ATTACHMENT A

ITEM 1

INCREASE REFUELING BORON CONCENTRATION

OMAHA PUBLIC POWER DISTRICT
FORT CALHOUN STATION-UNIT No.1

FIGURE
2-10

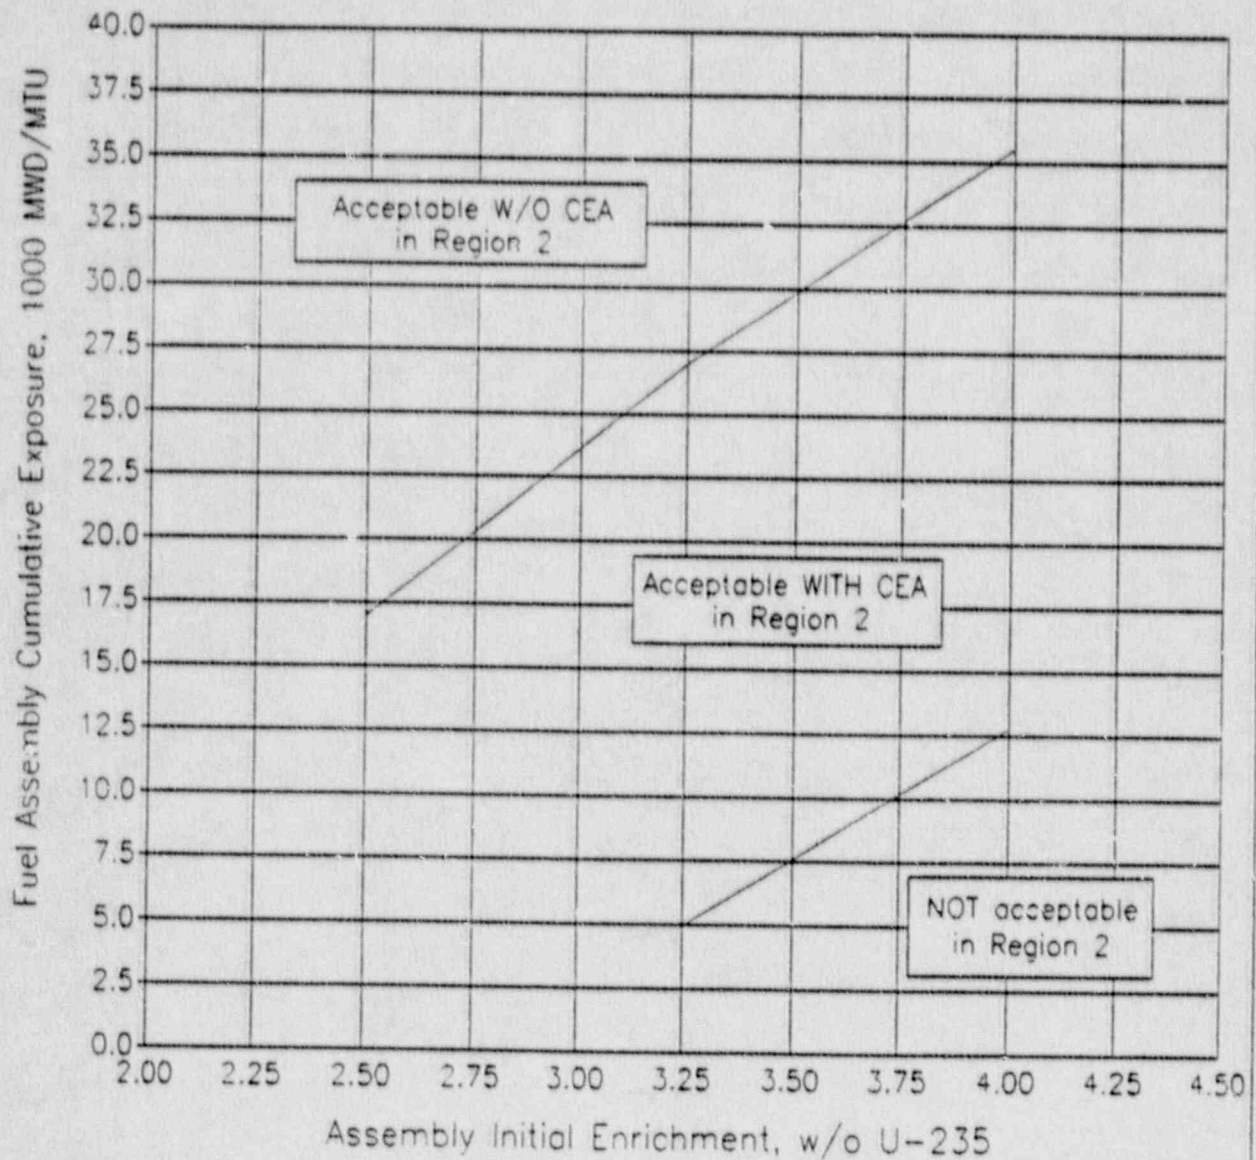
The spent fuel storage racks at the Fort Calhoun Station are organized into two regions. Either new fuel or discharged fuel may be stored in Region 1, but only spent fuel meeting the minimum exposure requirements of Technical Specifications Figure 2-10 may be stored in Region 2.

The worst case rack k_{∞} value including all biases and uncertainties must be maintained below 0.95. To allow for uncertainty in determining the actual exposure and interpolating between different enrichments, the exposure required for a k_{∞} of 0.9450 will be determined. For an initial enrichment of 3.25 w/o this exposure is 4,900 MWD/MTU. For an initial enrichment of 4.00 w/o this exposure is 12,800 MWD/MTU. These results are shown graphically in the proposed revision to Figure 2-10 of the Technical Specifications.

The Technical Specification document changes are defined by the updated Figure 2-10 of Section 2.8.

- 11 1127 Storage in Region 2 of the spent fuel racks shall be restricted to those assemblies whose parameters fall within the "acceptable" region of Figure 2-10.

- (12) Storage in Region 2 of the spent fuel racks shall be restricted to those assemblies whose parameters fall within the "acceptable" region of Figure 2-10.
